2020/0001/P	7 Oakeshott Avenue N6 6NT	External alterations including erection of single storey side and rear extension, installation of side and rear roof dormers and outdoor swimming pool in rear garden	Patrick Marfleet 1222
-------------	------------------------------	---	--------------------------

## Objection

### **Rear Garden**

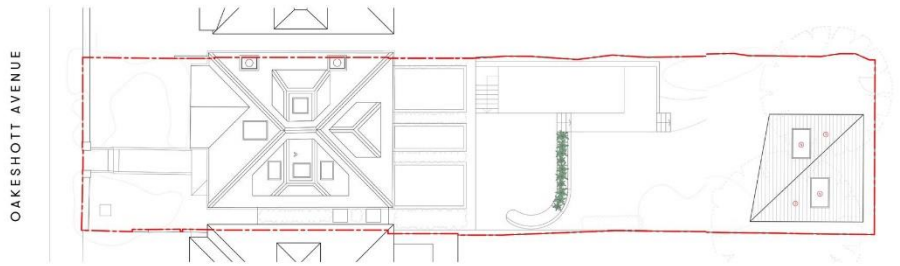
The aerial view shows 3 chimneys, 2 to the west of the ridge & 1 to the east, the latter does not appear on the drawings of the existing house.

All 3 chimneys should be preserved.

Proposed

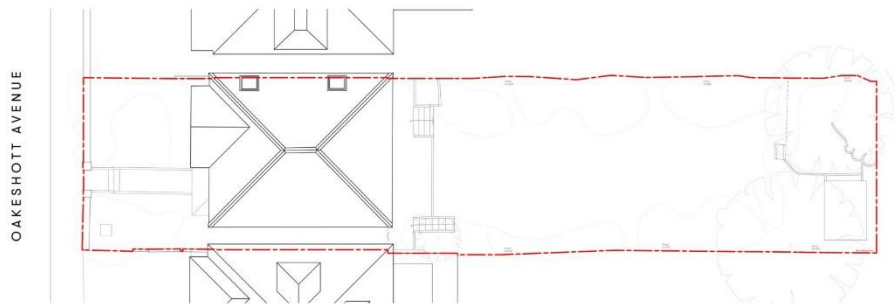
There is a concurrent 'certificate of lawfulness proposed' planning application for a garden room, 2020/0036/P. The drawings below show the effect of the 2 applications on the rear garden if both are implemented.

The proposed rear extension, swimming pool & garden house will result in c. 50% of the existing rear garden being developed into some form of hard structure (see drawing below), as such this appears to be over development and should be refused
